UNITED STATES PATENT AND TRADEMARK OFFICE

APPLICATION NO.	F	ILING DATE	FIRST NAMED INVENTOR	ATTORNEY DOCKET NO.	CONFIRMATION NO.
10/604,144	10/604,144 06/27/2003		Robert Wayne Gravely	11219.41656	1143
36790	7590	03/27/2006		EXAMINER	
TILLMAN		T, PLLC	RACHUBA, MAURINA T		
	BOX 471581 ARLOTTE, NC 28247			ART UNIT	PAPER NUMBER
	,			3723	- <u>-</u>
				DATE MAILED: 03/27/2006

DETAILED ACTION

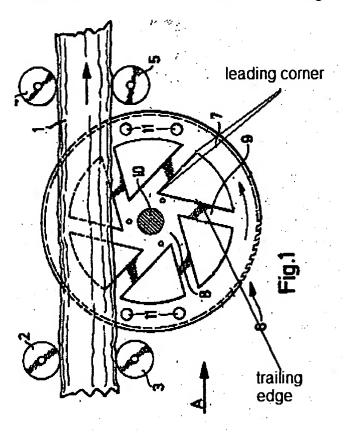
- 9. Applicant's arguments with respect to claims 18 and 26-33 have been considered but are most in view of the new ground(s) of rejection, based on applicant's amendments.
- 10. Applicant argues that '301 does not disclose the leading corner and trailing edge as defined in claim 26. The examiner disagrees.

Note that the leading corner is either corner as indicated, and the trailing edge is the edges indicated.
